Access Compliance Report

Public Rights-of-Way

Intersection ID: 22933	Main Street: GLEN_HOLLOW_CT	Cross Street: HUNTERS_LANDING_DR	Location: SE
ADA ID: D693C3811E30	Ramp Type: Perp	Initial Pass/Fail: Fail	Overall Compliance: No
		Severity Score: 12.5

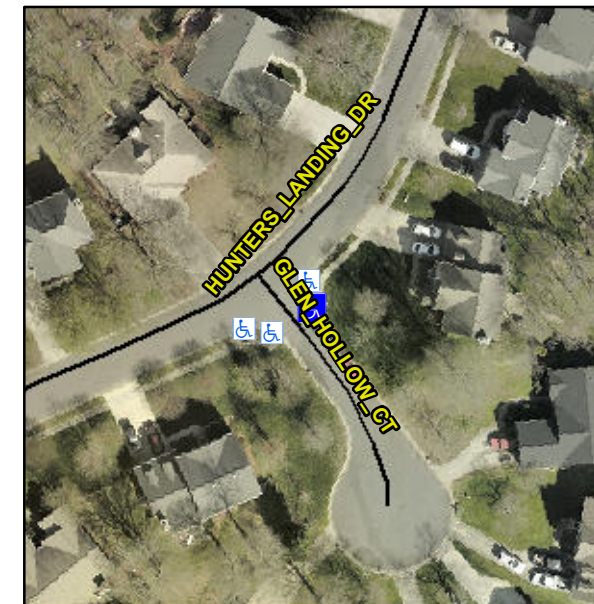
R304.2.2

Compliance	Description	Data	Compliance	Description	Data
N/A	Ramp Length (in)	93.0	No	Ramp Slope (%)	8.7
Yes	Ramp Width (in)	63.0	Yes	Ramp XSlope (%)	1.8
N/A	Flare Type LT	N/A	N/A	Flare Type RT	N/A
N/A	Flare Slope LT (%)	N/A	N/A	Flare Slope RT (%)	N/A
N/A	Flare Traversable LT?	N/A	N/A	Flare Traversable RT?	N/A
N/A	Landing Length (in)	N/A	N/A	DWS Provided?	N/A
N/A	Landing Width (in)	N/A	N/A	DWS Contrast?	N/A
N/A	Landing Slope (%)	N/A	N/A	DWS Length (in)	N/A
N/A	Landing X Slope (%)	N/A	N/A	DWS Full Width?	N/A
N/A	Landing Curb? (Y/N)	N/A	N/A	DWS Offset (in)	N/A
N/A	Shared Landing?	N/A			
N/A	Gutter Ponding?	N/A	N/A	Gutter Slope (%)	N/A
N/A	Gutter Lip Ht (in)	N/A	N/A	Gutter X Slope (%)	N/A
N/A	Painted X Walk1?	No	N/A	Painted X Walk2?	N/A
	X Walk 1 Direction	To SW		X Walk 2 Direction	N/A
N/A	X Walk 1 Width (in)	N/A	N/A	X Walk 2 Width (in)	N/A
	X Walk 1 Slope (%)	2.9		X Walk 2 Slope (%)	N/A
	X Walk 1 X Slope (%)	1.9		X Walk 2 X Slope (%)	N/A

Remove & Replace Entire Ramp.
